PART 6: Planning Applications for Decision

Item 6.1

Ref: 20/05326/FUL
 Location: 37 Kingswood Lane, Warlingham, CR6 9AB.
 Ward: Sanderstead
 Description: Demolition of single-family dwellinghouse and erection of 1x 3-storey block, containing 4x 3-bedroom, 3x 2-bedroom and 2x 1-bedroom flats with associated access, car parking, cycle and refuse storage.
 Drawing Nos: EX02-S1-101E; EX02-S1-102; EX02-S1-103E; EX02-S1-104B; EX02-S1-105C; EX02-S1-106D; EX02-S1-107B; EX02-S1-108B; EX02-S1-109B; EX02-S1-110C; EX02-S1-111A; EX02-S1-112C; EX02-S1-113A; EX02-S1-114B; EX02-S1-115; EX02-S1-116; EX02-S1-117.
 Applicant: Mr Shervin Khazeni of Aventier Ltd
 Case Officer: Nathan Pearce

Fig 1: Site plan

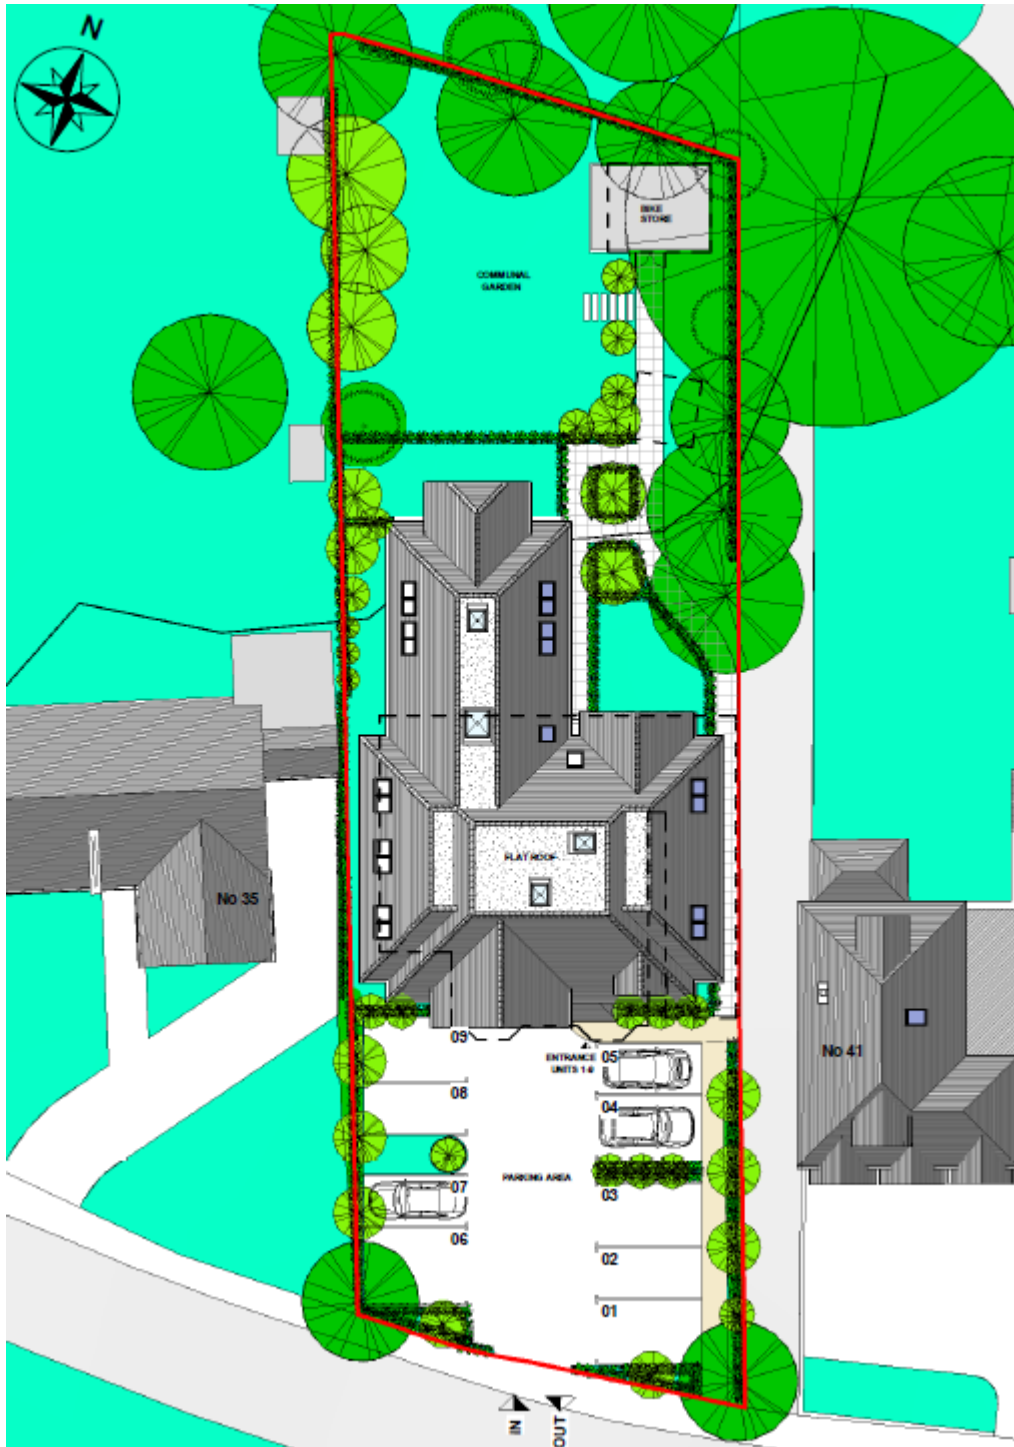
- Demolition of existing detached house
- Erection of a two-storey building plus accommodation in roof-space.
- Provision of 2 x 1 bedroom flats, 3 x 2 bedroom flats (3 person) and 4 x 3 bedroom flats.
- Provision of 9 off-street parking spaces including one disabled bay.
- Provision associated refuse/cycle stores.

3.2 Amended plans were received on 03.02.2021 showing the introduction of a lift, internal reconfiguration of unit 1, additional high level windows, minor alterations to the landscaping and hardstanding, introduction of bulky goods storage area, minor amendments to the finish materials.

Fig 4: Proposed site plan showing proposal in relation to neighbouring properties

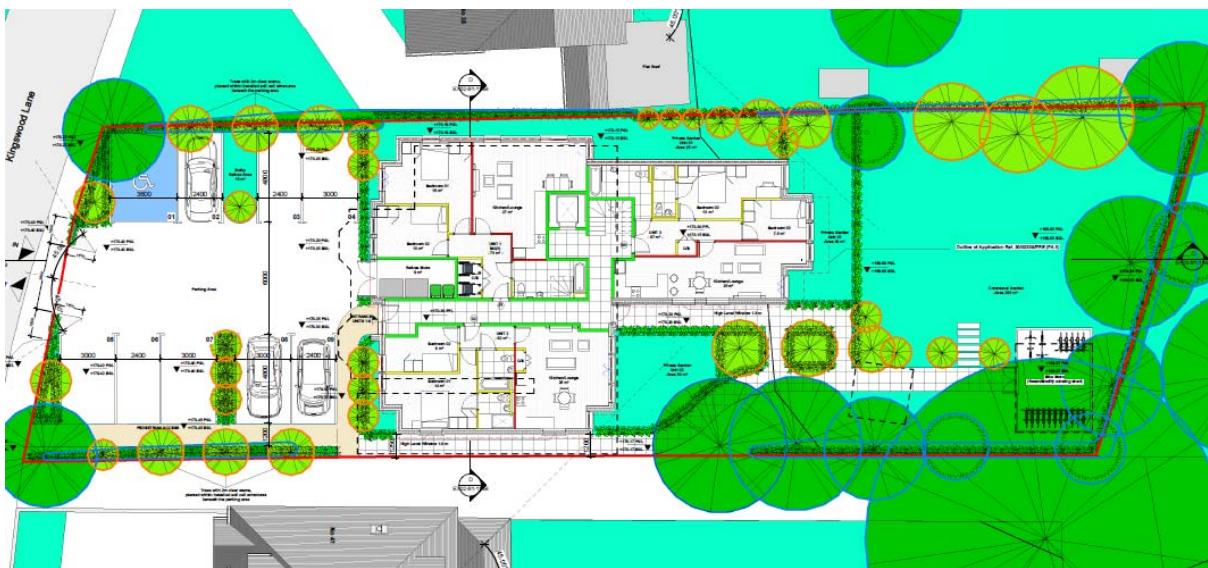
8.11 Policy DM10.2 seeks to create well defined and designed public and private spaces and advises that forecourt parking should only be allowed where it does not cause undue harm to the character or setting of the building and is large enough to accommodate parking with sufficient screening to prevent vehicles encroaching on the public highway. Whilst the frontage would be given over to hard-standing to allow for off street parking there would be some soft landscaping surrounding it, along with a section of soft landscaping along the boundary. Given the overall scale of the development and number of forecourt hardstanding areas in the vicinity, the extent of hardstanding would not be excessive. The site would offer sufficient opportunities for soft landscaping to the rear.

8.12 The application site is a substantial plot within an established residential area. The scale and massing of the new buildings would generally be in keeping with the overall scale of development found in the immediate area whilst sensitively intensifying it and the layout of the development would respect the streets' pattern and rhythm.

Fig 6: Proposed site plan

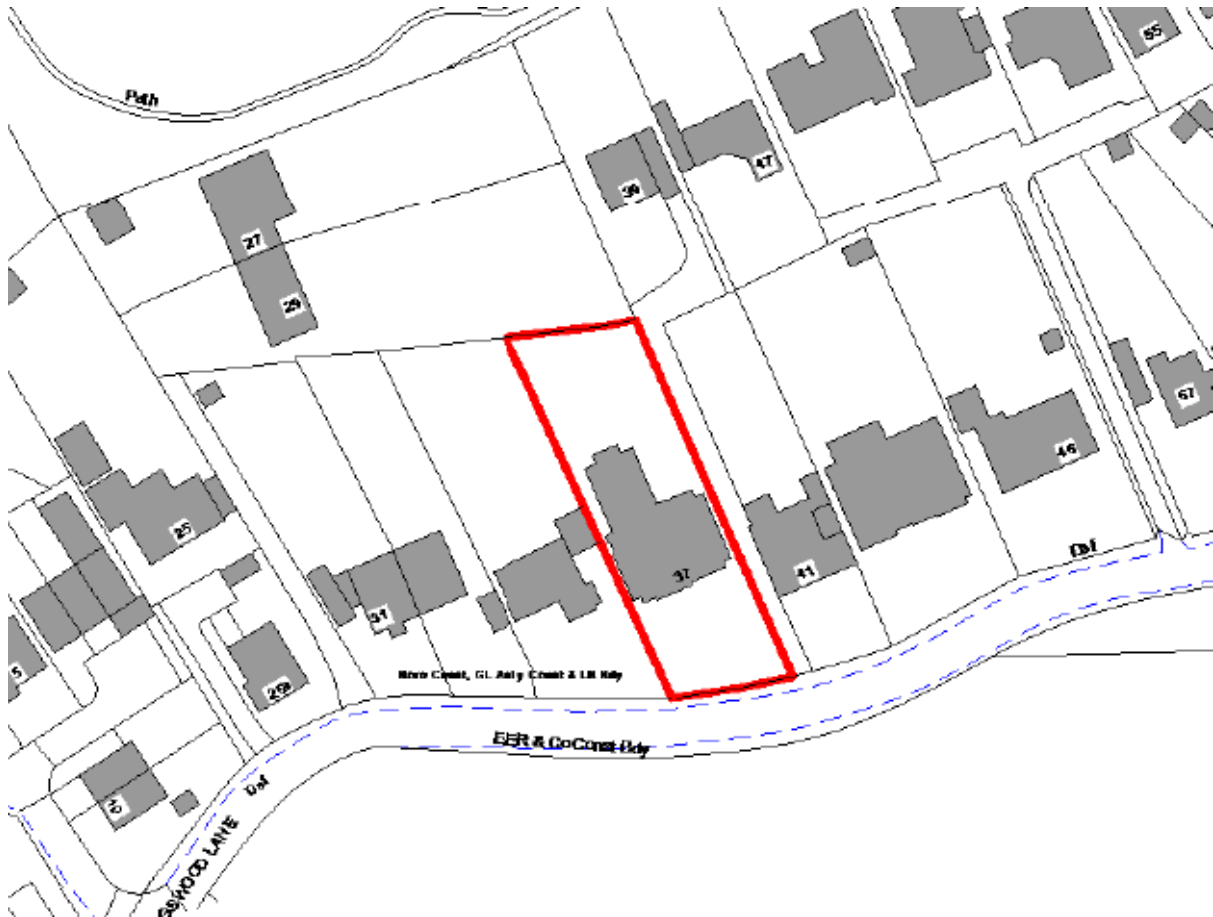
- 8.14 This dwelling is to the west of the proposal site. The rear of the proposed building would not break a 45 degree line drawn from rear habitable room windows. There are 2 windows in the side elevation at ground level and none at first floor level. One is obscure glazed and the other appears to serve a bedroom, with another bedroom to the front and the main living area on the opposite side of the building. The proposal would have an impact on the side facing bedroom window in terms of a loss of light and outlook. This window is to an extent already affected by the existing building and boundary fence, but the impact would be greater. Officers are satisfied that the proposal is acceptable despite this impact; the Suburban Design Guide gives very little protection to side facing windows which directly overlook adjacent sites. Additionally as it serves a bedroom, to which it is generally accepted that light is less important, is side facing and faces towards the neighbouring property and the impact on the other windows serving this property is minimal, officers are satisfied that this impact is acceptable.

- 8.19 This dwelling is to the east of the proposal site. An access road that serves no.39 passes between the proposal site and no.41. The rear of the proposed building would not break a 45 degree line drawn from the first floor rear habitable room dormer window. At ground floor there is an extended conservatory, a 45 degree line drawn from the rear of this conservatory would not be broken. There are 4 windows on the side elevation at ground floor and none at first floor level. One is a very small window, two are secondary windows serving a lounge to the rear and one is a secondary window serving a front reception room, which is already served by a very large window on the front elevation. Although there may be some loss of light to these windows they are side facing windows which already have their outlook limited by the existing building are not considered to be primary windows to habitable rooms. A conservatory is present at the rear of no.41, the proposal would not break a horizontal 45 degree line when the line is drawn from the rear of the conservatory.
